Access Compliance Report

Public Rights-of-Way

Intersection ID: 21549	Main Street: S_TRYON_ST	Cross Street: SANDY_PORTER_RD	Location: SW
ADA ID: B896CC072677	Ramp Type: Perp	Initial Pass/Fail: Fail	Overall Compliance: No
		Severity Score: 12.5

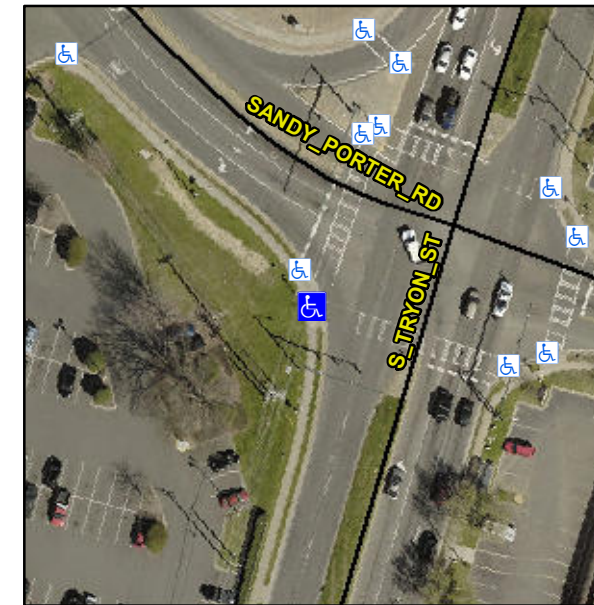
Not Found, R304.2.2

Compliance	Description	Data	Compliance	Description	Data
N/A	Ramp Length (in)	43.0	No	Ramp Slope (%)	9.4
Yes	Ramp Width (in)	48.0	Yes	Ramp XSlope (%)	0.6
N/A	Flare Type LT	N/A	N/A	Flare Type RT	N/A
N/A	Flare Slope LT (%)	N/A	N/A	Flare Slope RT (%)	N/A
N/A	Flare Traversable LT?	N/A	N/A	Flare Traversable RT?	N/A
N/A	Landing Length (in)	N/A	N/A	DWS Provided?	N/A
N/A	Landing Width (in)	N/A	N/A	DWS Contrast?	N/A
N/A	Landing Slope (%)	N/A	N/A	DWS Length (in)	N/A
N/A	Landing X Slope (%)	N/A	N/A	DWS Full Width?	N/A
N/A	Landing Curb? (Y/N)	N/A	N/A	DWS Offset (in)	N/A
N/A	Shared Landing?	N/A			
N/A	Gutter Ponding?	N/A	N/A	Gutter Slope (%)	N/A
N/A	Gutter Lip Ht (in)	N/A	N/A	Gutter X Slope (%)	N/A
N/A	Painted X Walk1?	Yes	N/A	Painted X Walk2?	N/A
	X Walk 1 Direction	To SE		X Walk 2 Direction	N/A
N/A	X Walk 1 Width (in)	112.0	N/A	X Walk 2 Width (in)	N/A
	X Walk 1 Slope (%)	0.3		X Walk 2 Slope (%)	N/A
	X Walk 1 X Slope (%)	0.9		X Walk 2 X Slope (%)	N/A

Remove & Replace Entire Ramp.
